From: Xiaosong Yin
To: Keith Lockie
Date: 06/15/2006 8:29:02 AM
Subject: Additional information request

Follow-up Items from 6/1/06 Meeting with DOE on INL TFF Waste Determination

NRC Meeting with DOE-ID on RAI responses for

Draft Section 3116 Waste
Determination

New Geologic Cross-Section

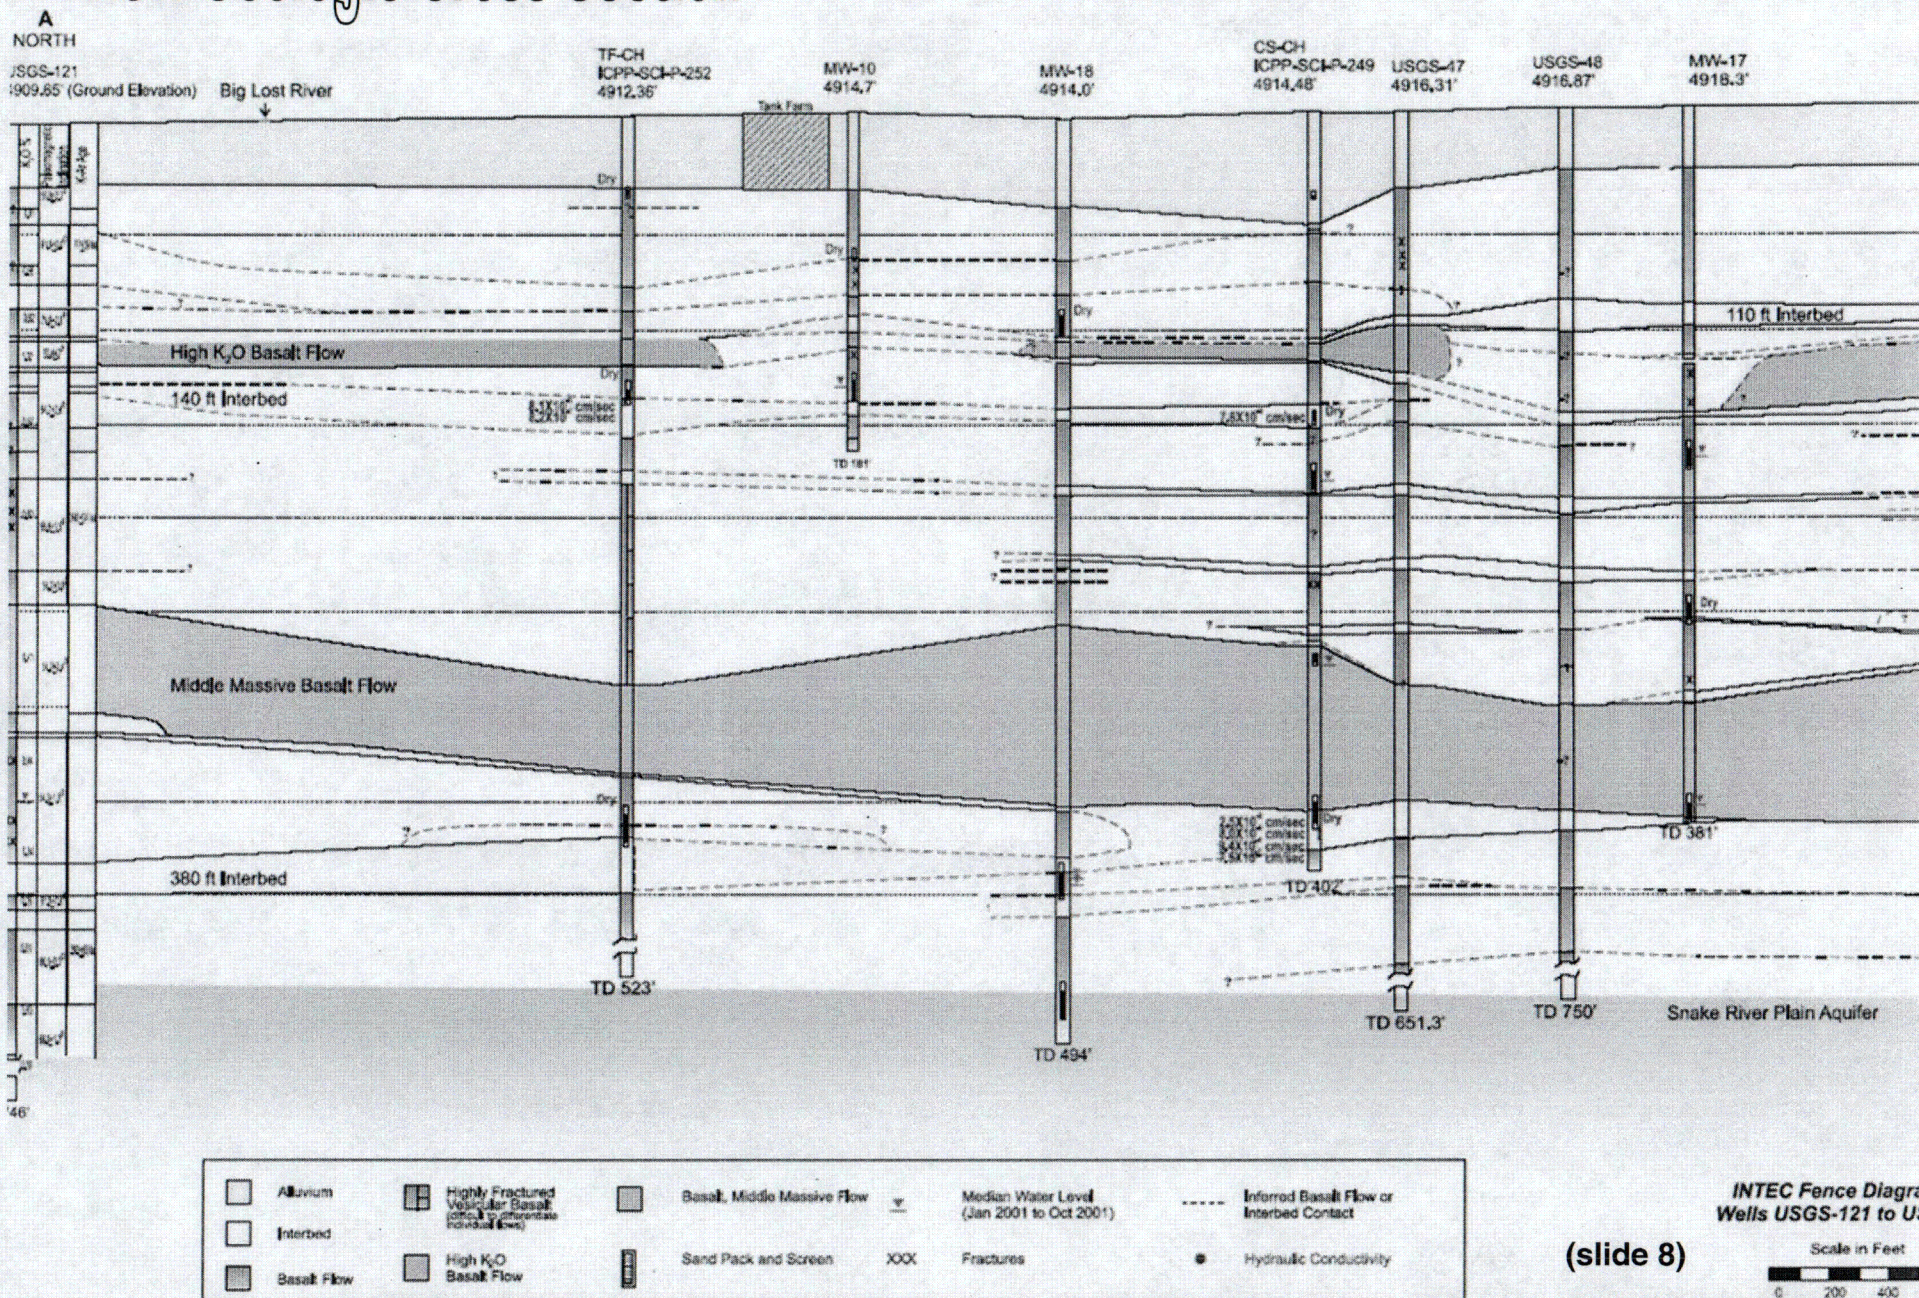
--DOE-ID should provide the reference that contains a new west/east geologic cross-section B-B' that is illustrated in Figure 3-4 of "Evaluation of Tc-99 in Groundwater at INTEC: Summary of Phase I Results" (ICP/EXT-04-00244). The reference from ICP/EXT-04-00244 that contains this cross-section is "Phase 1 Monitoring Well and Tracer Study Report for Operable Unit 3-13, Group 4, Perched Water," DOE/ID-10967, Revision 1, 2003. DOE-ID did not provide the most recent geologic cross-sections for the study area in response to NRC RAI 12. Slide 7 and Issue

Figure 4-2. Groundwater modeling domain showing ^{99}Tc concentrations and location of maximum concentrations (all concentrations based on a unit source inventory).^{ee}

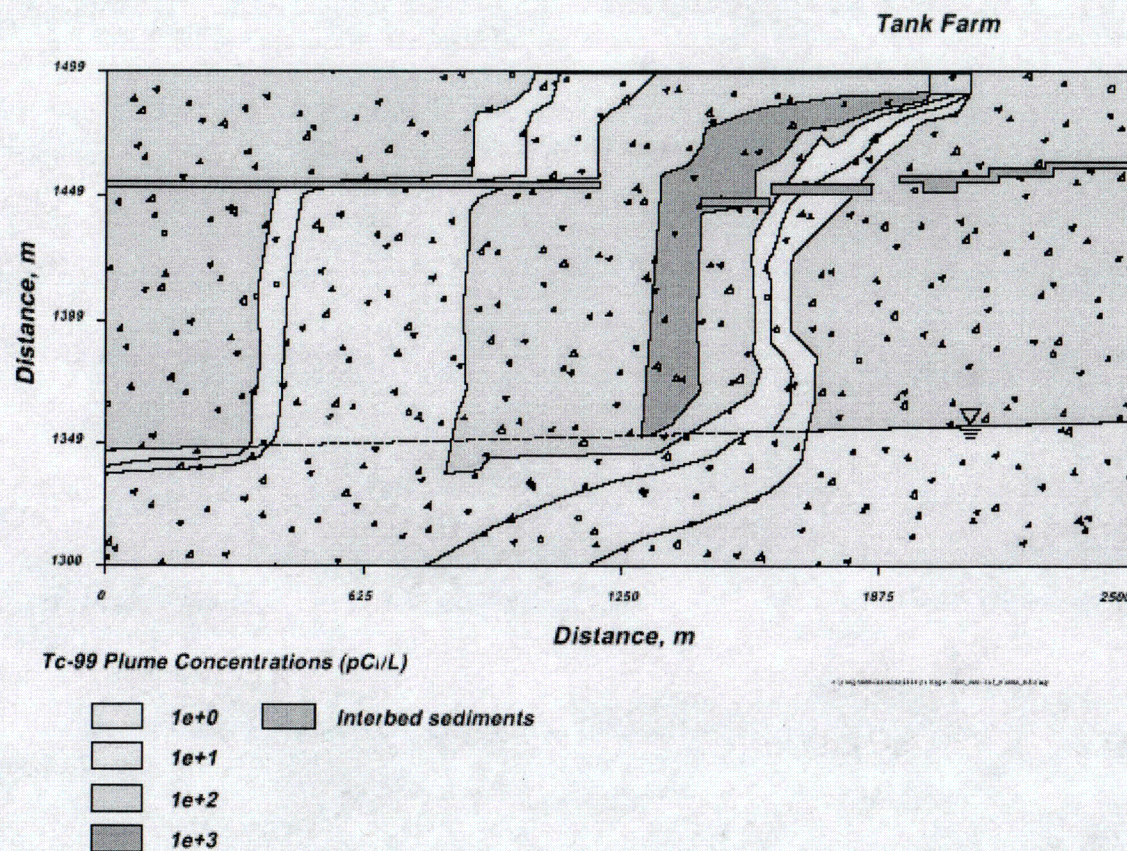
--DOE-ID should provide center-line plume concentrations (as depicted in Figure 4-2 of the PA) as a function of time for modeled radionuclides at key locations in table format and a figure showing these locations. Locations should include the following grid cells: 1.) directly underneath the TFF in the perched water, 2.) near the "spillway" in the perched water, and 3.) in the saturated zone. DOE-ID revised the time of peak release for Tc-99 in Table 4-1 of the PA in response to RAI #13. The source of the error described in the RAI response is not clear. Furthermore, the travel time to saturated groundwater is difficult to determine with the use of scientific notation which truncates the year of maximum concentration in groundwater for Tc-99 (DOE-ID should provide the travel time in years). The information requested above is also needed to clarify to what extent Sr-90 concentrations are reduced due to attenuation in the 600 meters of lateral transport in the unsaturated zone, which cannot be determined easily from the currently available information. Slide 10 and Issue 2

--DOE-ID should try to provide a better explanation regarding the large lateral extent (0.5-1 mile) of the contaminant plume near-surface and as it enters the saturated zone. For example, is the large lateral extent near-surface indicative of perched water in the alluvium? DOE-ID should also explain why the contaminant plume is depicted at the surface of the model domain in Figure 4-2 of the PA when the tanks are located at approximately 45 feet below grade. Slide 11
